ATTACHMENT "A" (Marked-Up Proposed Specifications) Unit 2

SAN ONOFRE--UNIT 2

Figure 3.1.9-1

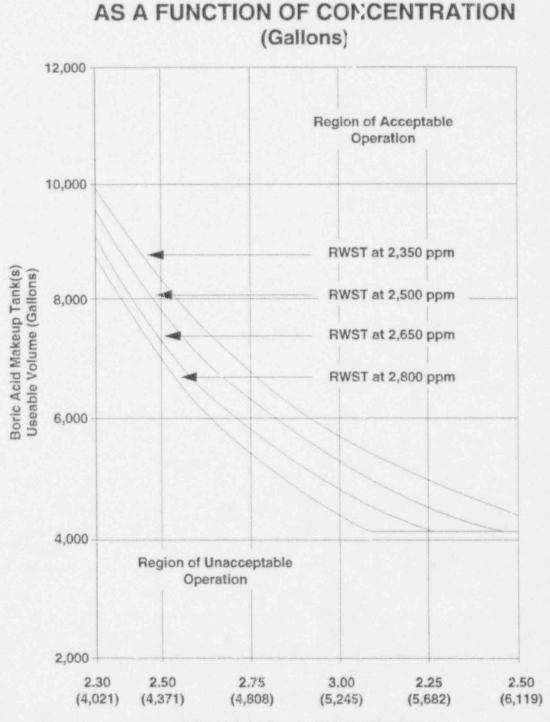
Boration Systems - Operating 3.1.9

MINIMUM STORED BOR'C ACID VOLUME

Figure 3.7.7.1-1

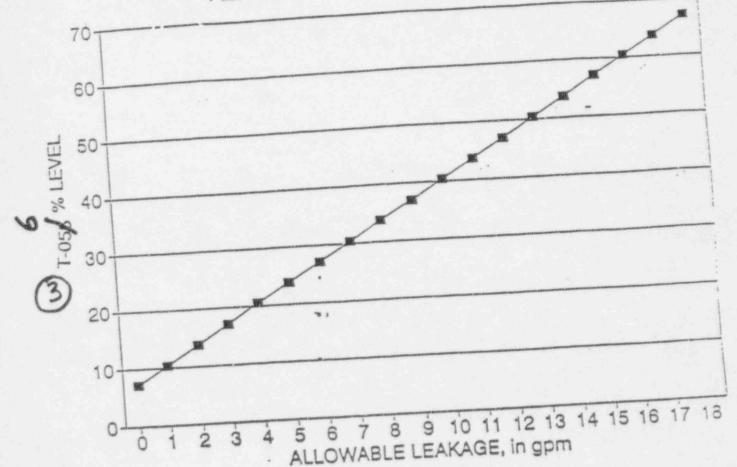
SURVEILLANCE	FREQUENCY
SR	3.7.7.1.1	Verify the contained water volume in the Primary Plant Makeup Storage Tank is within its limits.	7 days
SR	3.7.7.1.2	Verify each CCW Safety Related Makeup pump develops the required differential pressure on recirculation flow.	In accordance with inservice testing program
SR	3.7.7.1.3	Measure CCW Leakage.	24 months

Figure 3.1.9-1

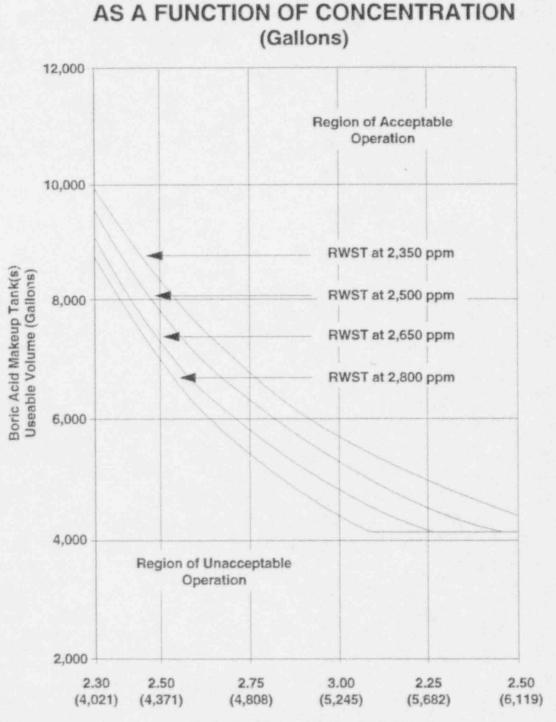
Boration Systems - Operating 3.1.9

MINIMUM STORED BORIC ACID VOLUME
